PART 573 Defect and Noncompliance Report3

Make and model: EarthRoamer XV-LT

Subject: Required Front Camper Mount Inspection and Replacement	Bulletin No: 0008 rev A
	Issued: 09/27/2006

Subject: SAFETY RECALL Required Front Camper Mount Inspection and Replacement	Bulletin No: 0008 rev B
	Issued: 10/11/2006

ATTACHMENT A

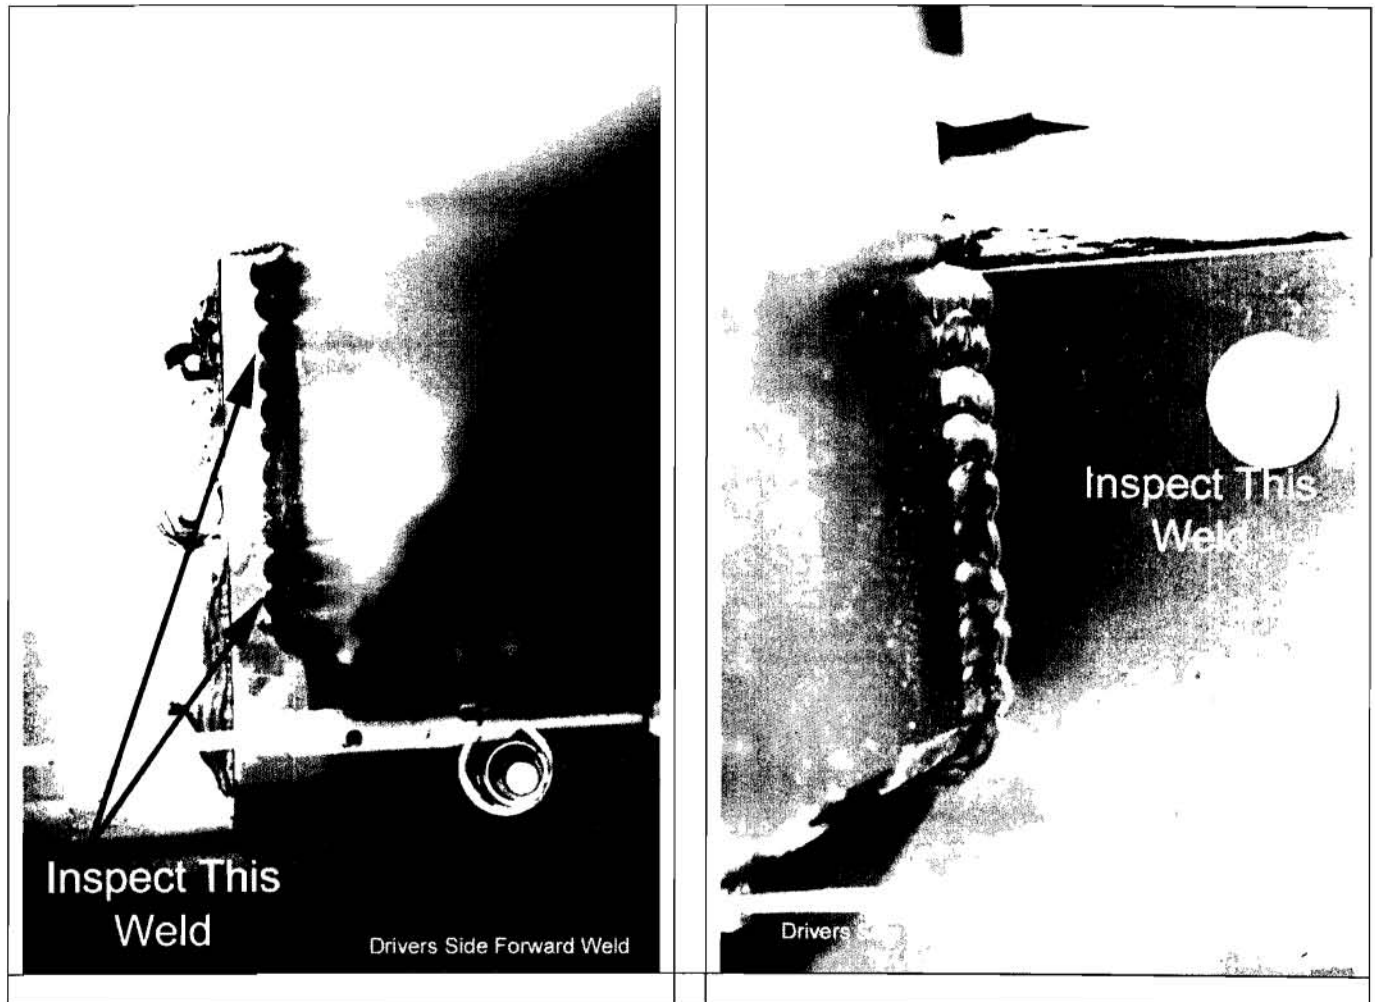
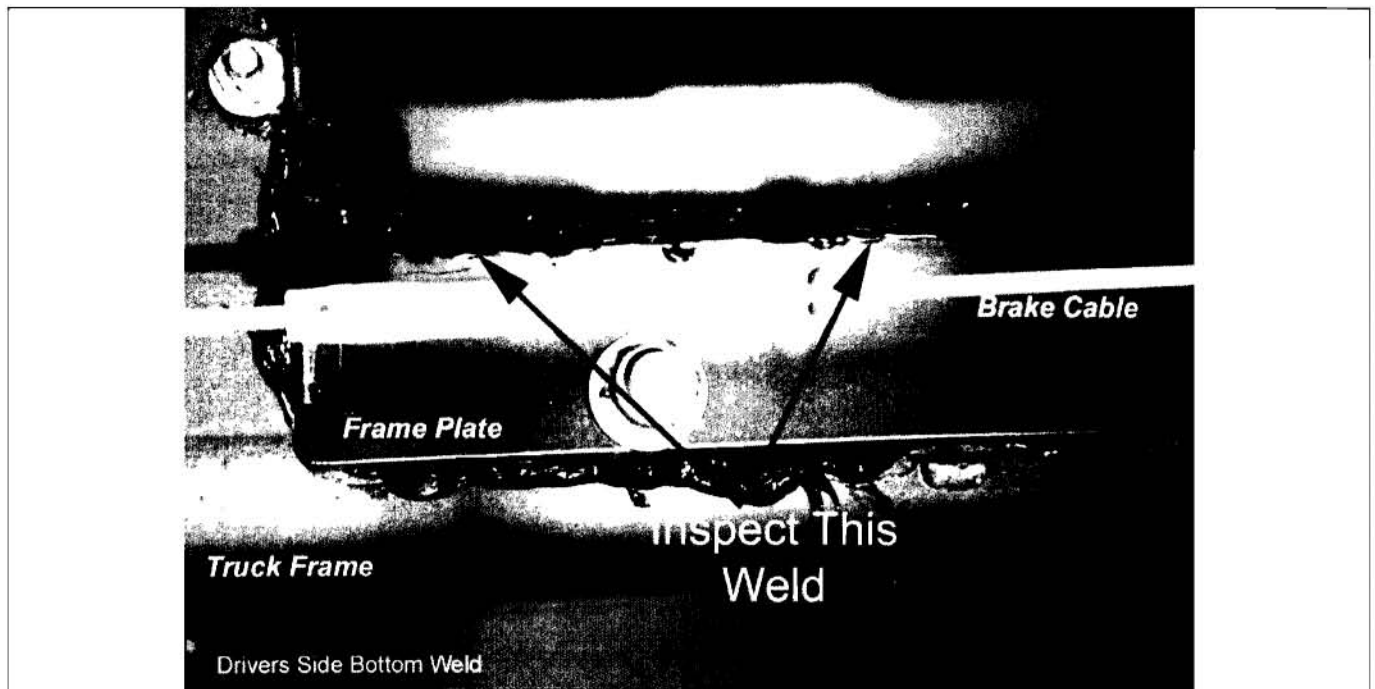
The welds that attach the frame plate to the camper mount need to be visually inspected for any signs of cracking. The photos in Attachment A show the front mount assembly prior to installation of the camper body to clearly illustrate each of the weld locations. There is also a photo included of an actual mount on a completed vehicle.

The weld strength is insufficient to carry the loads on the camper mount.

Over time cracks may develop in the camper mount welds eventually resulting in broken welds. Small hairline cracks serve as a visual indicator that the weld is compromised.

Revision B and C camper mounts that are subject to weld cracking are being replaced with a redesigned camper mount. The redesigned camper mount has thicker frame plates, is welded with continuous welds, and is welded on both sides of the vertical plates. The production remedy is the same as the field remedy. This remedy was implemented in production beginning with unit #29.

Camper mount before camper has been installed. These photos show revision D mounts with a continuous weld bead. Your mounts will be stitch welded.

Driver Side

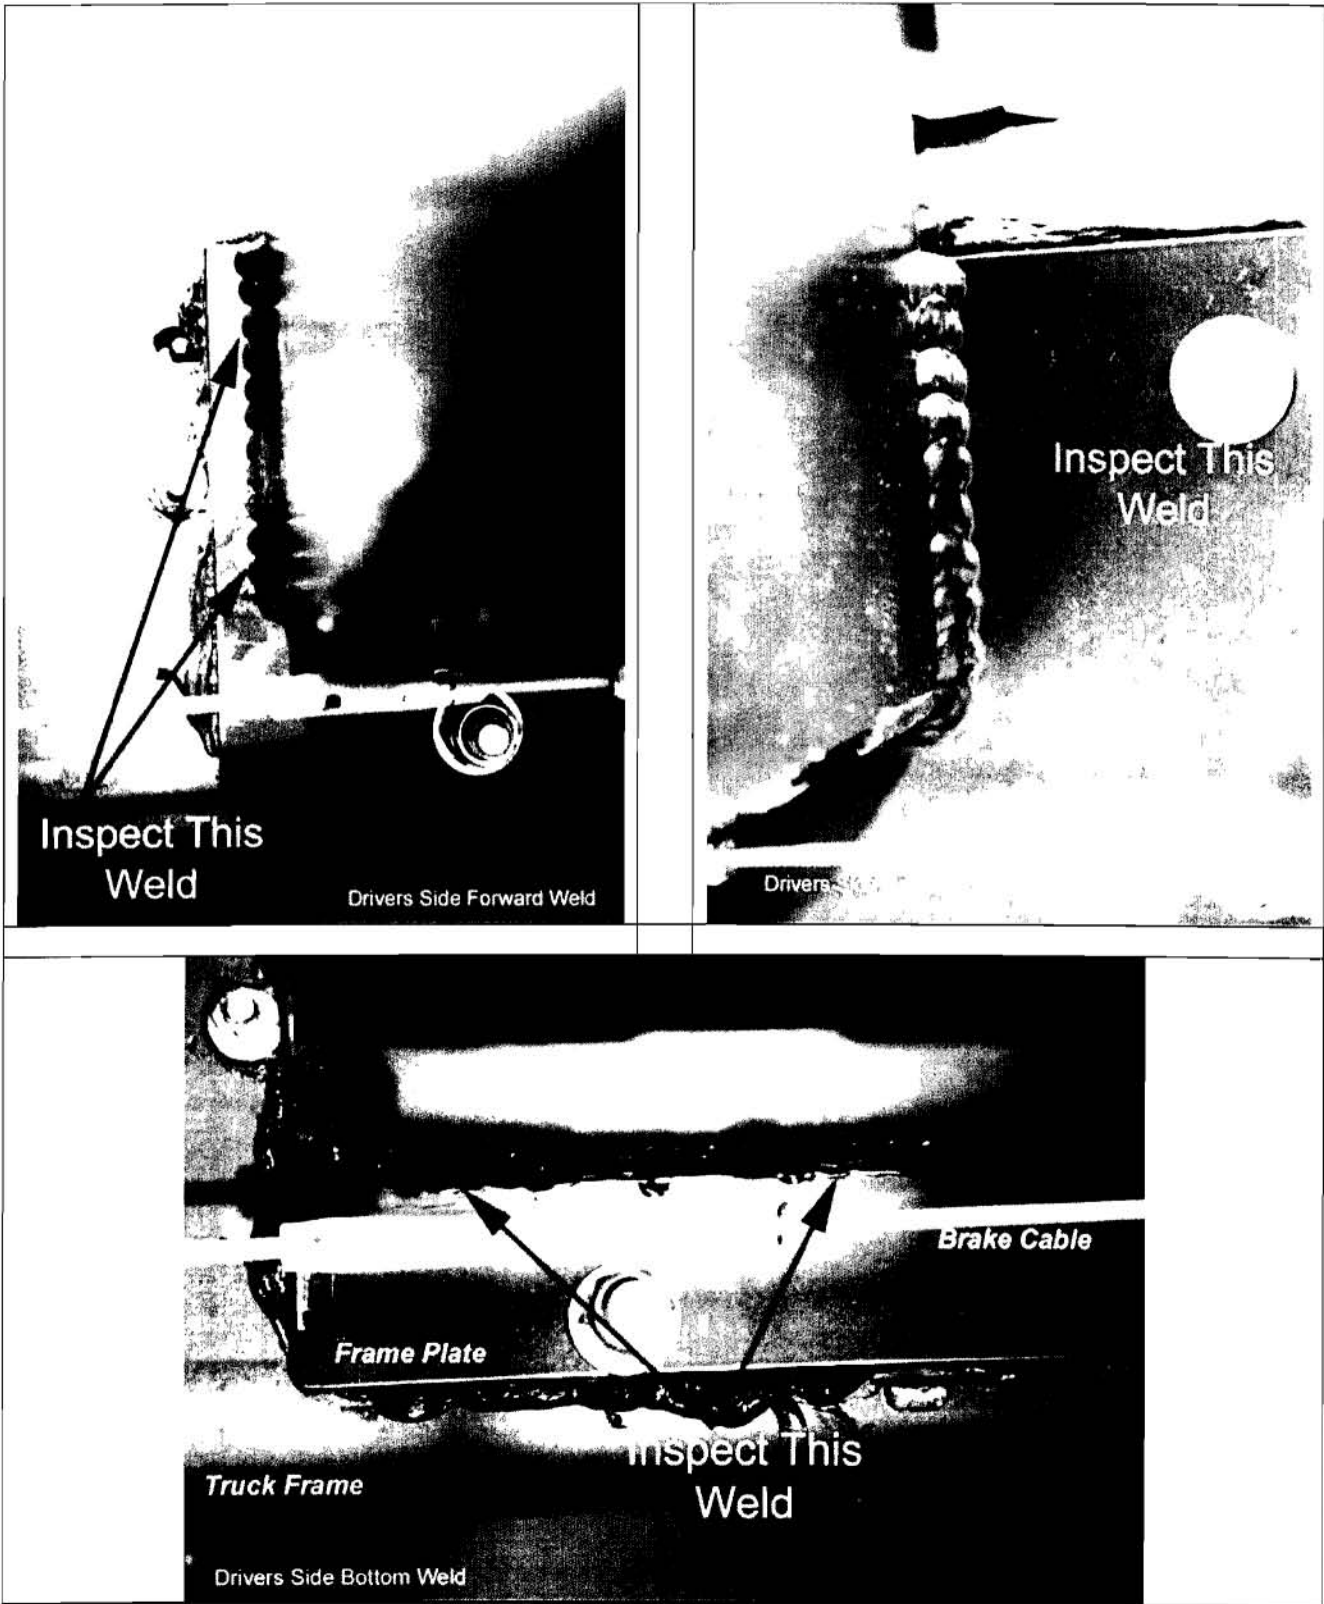
2. The area to be inspected is located between the truck frame and fiberglass camper body fairing.
3. The welds that attach the frame plate to the camper mount need to be visually inspected for any signs of cracking. Clean the area as needed to provide clear viewing of the area of concern. There are a total of 6 locations that need to be inspected (three on the passenger side mount and three on the drivers side mount). The photos below show the front mount assembly prior to installation of the camper body to clearly illustrate each of the weld locations. There is also a photo included of an actual mount on a completed vehicle to more clearly represent at what you will be looking.

All revision B or C front camper mounts will need to be replaced with revision D mounts as soon as feasibly possible to ensure driver safety. Each circumstance will be addressed and the repair method handled individually.

Camper mount before camper has been installed. These photos show revision D mounts with a continuous weld bead. Your mounts will be stitch welded.

Passenger Side

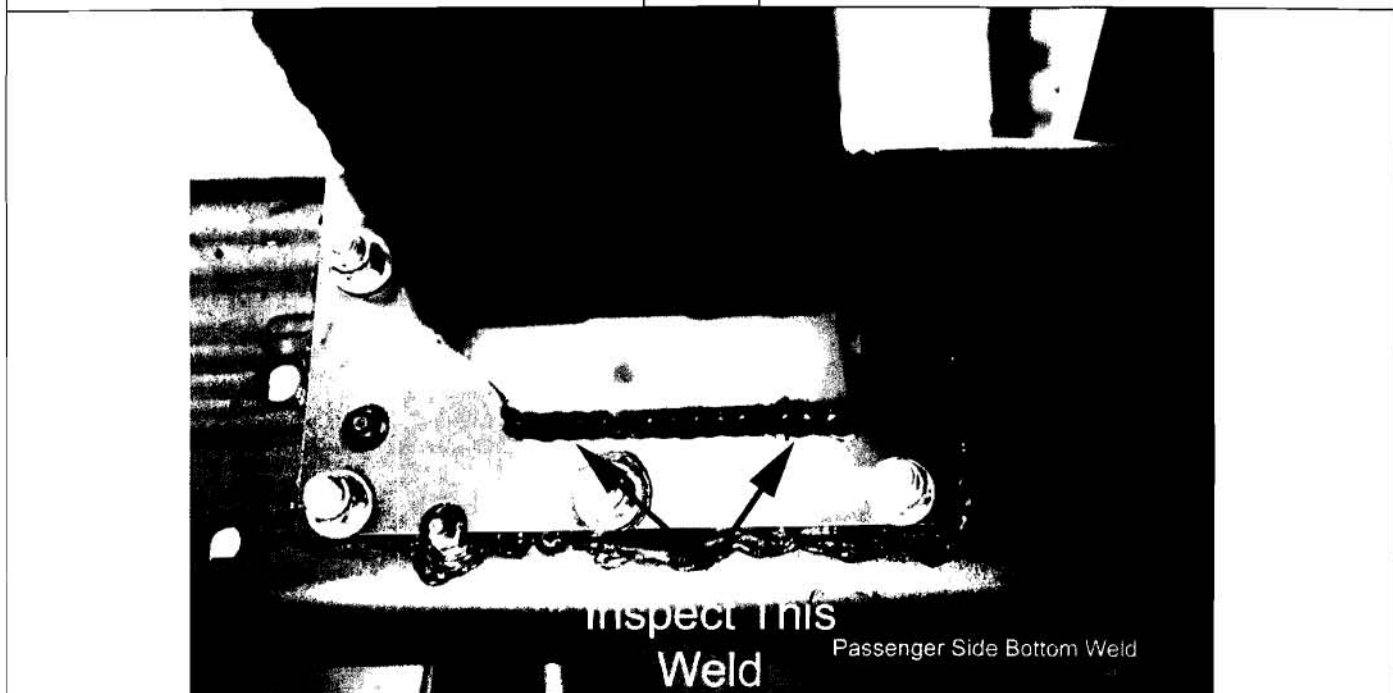
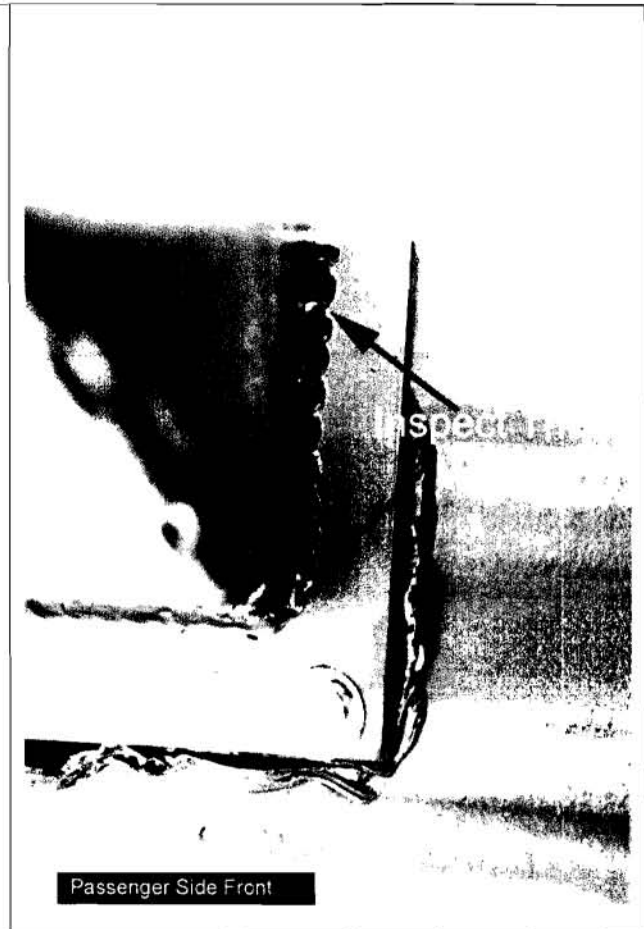
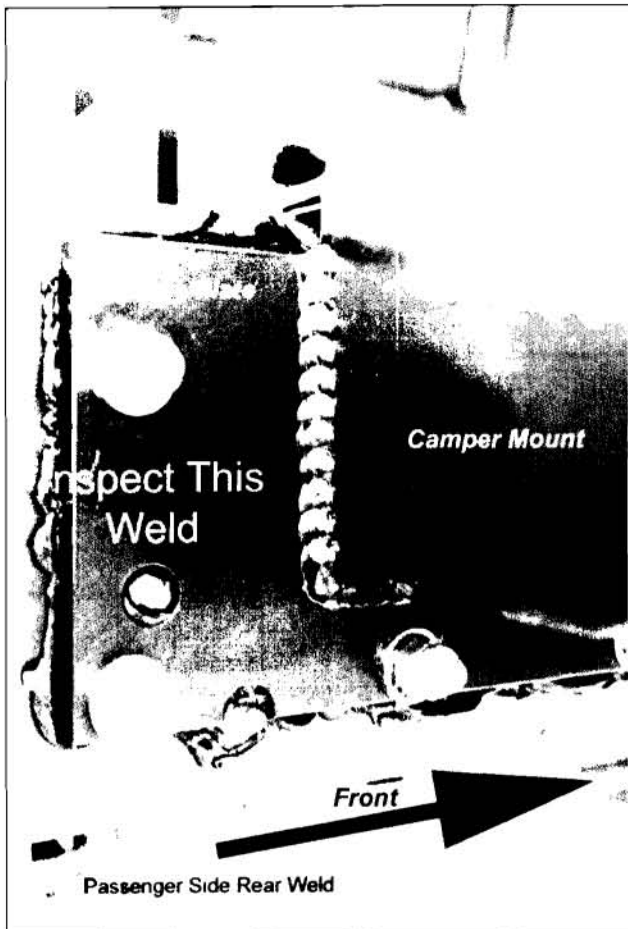
2. The area to be inspected is located between the truck frame and fiberglass camper body fairing.
3. The welds that attach the frame plate to the camper mount need to be visually inspected for any signs of cracking. Clean the area as needed to provide clear viewing of the area of concern. There are a total of 6 locations that need to be inspected (three on the passenger side mount and three on the drivers side mount). The photos below show the front mount assembly prior to installation of the camper body to clearly illustrate each of the weld locations. There is also a photo included of an actual mount on a completed vehicle to more clearly represent at what you will be looking.

All revision B or C front camper mounts will need to be replaced with current revision mounts as soon as feasibly possible to ensure driver safety. Each circumstance will be addressed and the repair method handled individually.

Camper mount before camper has been installed. These photos show revision D mounts with a continuous weld bead. Your mounts will be stitch welded.
